Access Compliance Report

Public Rights-of-Way

Intersection ID: 16042	Main Street: POINDEXTER_DR	Cross Street: SUNSET_DR	Location: W
ADA ID: 7C051AA863E5	Ramp Type: Directional1	Initial Pass/Fail: Fail	Overall Compliance: No
		Severity Score: 22.5

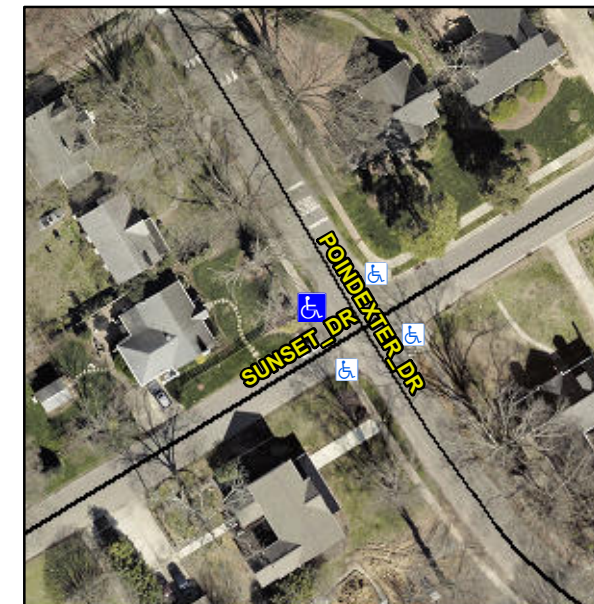
NO CURB

R304.5.1, R304.2.2, R304.5.3

Compliance	Description	Data	Compliance	Description	Data
N/A	Ramp Length (in)	103.0	N/A	Grade Break?	N/A
No	Ramp Width (in)	39.0	N/A	Grade Break Slope (%)	0.0
No	Ramp Slope (%)	10.3	N/A	Grade Break XSlope (%)	0.0
No	Ramp XSlope (%)	3.6			
N/A	Flare Type LT	N/A	N/A	Flare Type RT	N/A
N/A	Flare Slope LT (%)	N/A	N/A	Flare Slope RT (%)	0.0
N/A	Flare Traversable LT?	N/A	N/A	Flare Traversable RT?	N/A
N/A	Landing Length (in)	0.0	N/A	DWS Provided?	N/A
N/A	Landing Width (in)	0.0	N/A	DWS Contrast?	N/A
N/A	Landing Slope (%)	0.0	N/A	DWS Length (in)	N/A
N/A	Landing X Slope (%)	0.0	N/A	DWS Full Width?	N/A
N/A	Landing Curb? (Y/N)	N/A	N/A	DWS Offset LT (in)	N/A
N/A	Shared Landing?	N/A	N/A	DWS Offset RT (in)	N/A
N/A	Gutter Ponding?	0.0	N/A	Gutter Slope (%)	N/A
N/A	Gutter Lip Ht (in)	0.0	N/A	Gutter X Slope (%)	N/A
N/A	Painted X Walk1?	No		Road Slope (%)	1.2
	X Walk 1 Direction	To SE		Road X Slope (%)	3.9
	X Walk 1 Width (in)	N/A		Clear Space?	N/A

Remove & Replace Entire Ramp.
